**ADDENDUM NO. 1**

**ELEVATED WATER STORAGE TANK AND WATER TREATMENT  
BUILDING - DRINKING WATER STATE REVOLVING FUND -  
DW2020013**

**PROJECT # 2020-09**

December 4, 2021

### ELEVATED WATER STORAGE TANK

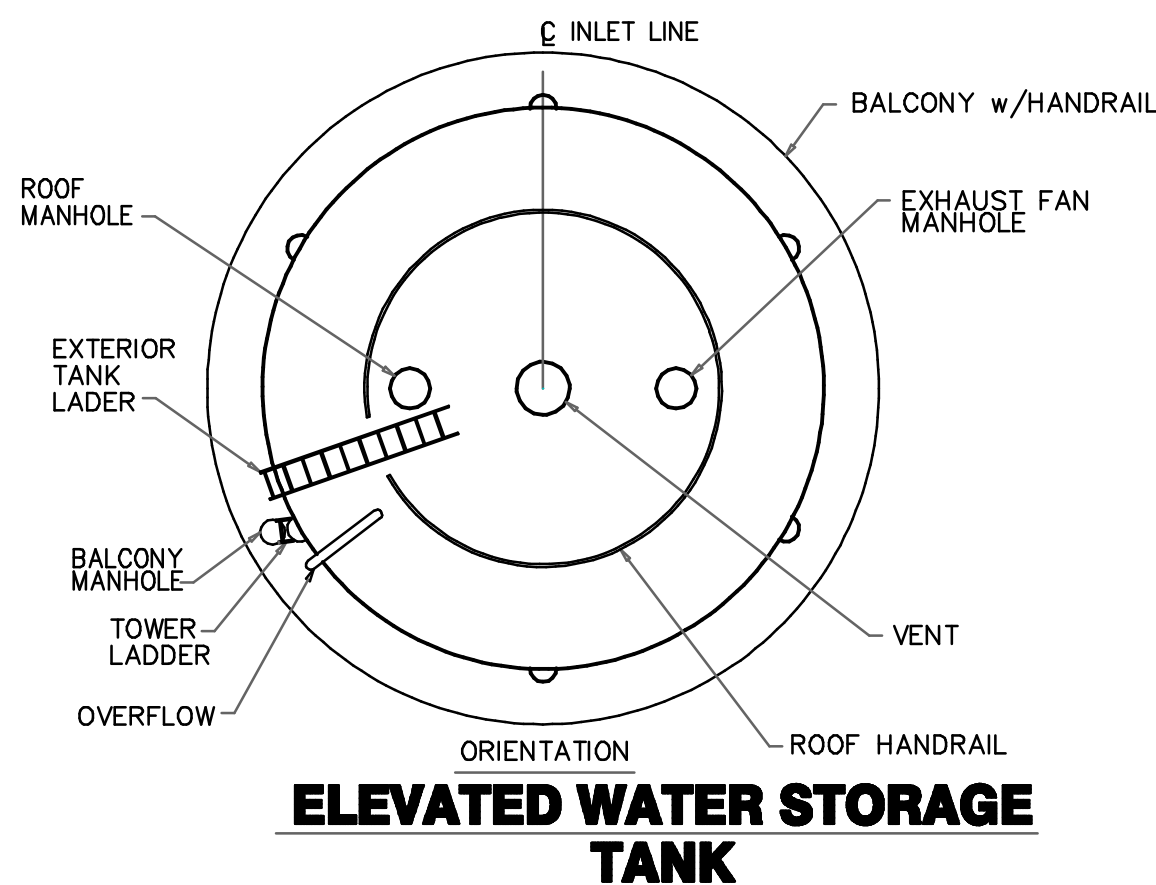
- A. Sheet C6 of 19, replace with attached revised Sheet C6 of 19 with the revision date of 12/4/21. The notes in the Elevated Water Storage Tank Detail were revised to specify diameter and schedule of the inlet and outlet pipes.
-

- INLET PIPE TO BE A 4" PIPE THAT IS REDUCED TO A 2" CONICAL ORIFICE ORIENTED IN A VERTICAL DIRECTION.  
- INLET PIPE TO BE 4" DIAMETER SCH 40 STEEL AND OUTLET PIPE TO BE AN 8" DIAMETER SCH 40 STEEL PIPE. STEEL PIPE WILL TRANSITION TO DUCTILE IRON PIPE AT GROUND SURFACE.
